Amendment of Drawings

Title: SEMICONDUCTOR STRUCTURES WITH
STRUCTURAL HOMOGENEITY
Inventor: Westhoff et al.
Serial No. 10/765,372
Atty Docket No.: ASC-066
Attorney for Applicant: Natasha C. Us
Sheet 1 of 1 ANNOTATED SHEET

FIG. 5

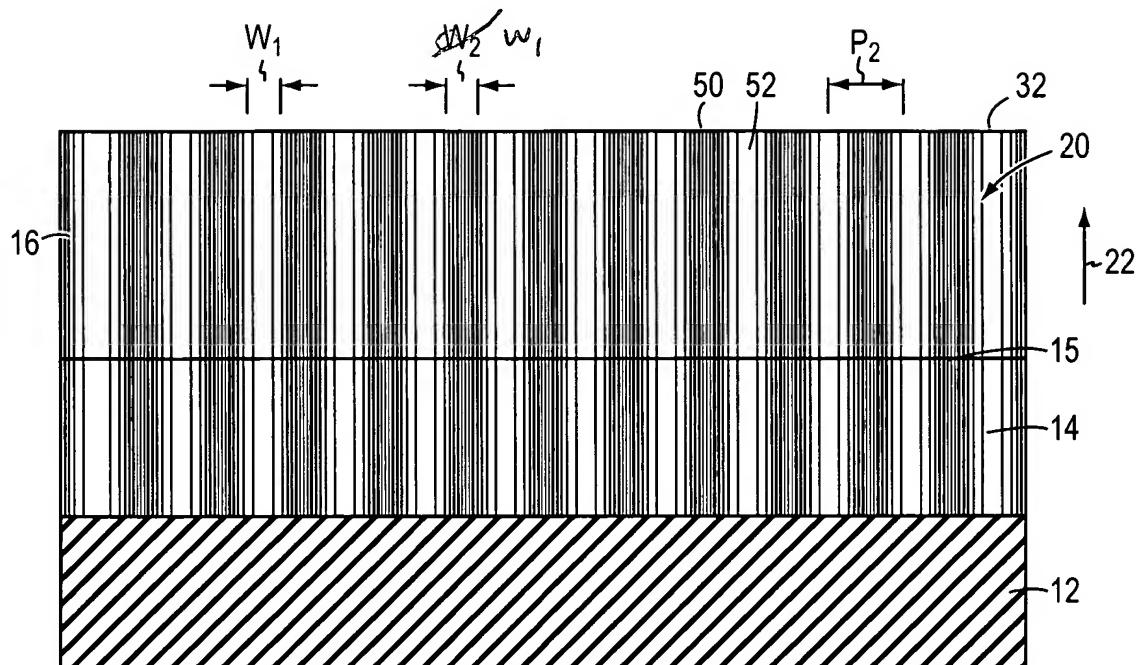
A proposed amendment to Figure 5 is shown in red ink on the attached drawing sheet entitled “Annotated Sheet.” Specifically, the column 52 is correctly indicated to have a width of W_1 , rather than W_2 .

In amended Figure 5, a width of column 52 is correctly indicated as “W₁.” Support for this amendment is found in the specification, for example, at page 11, lines 13–16.
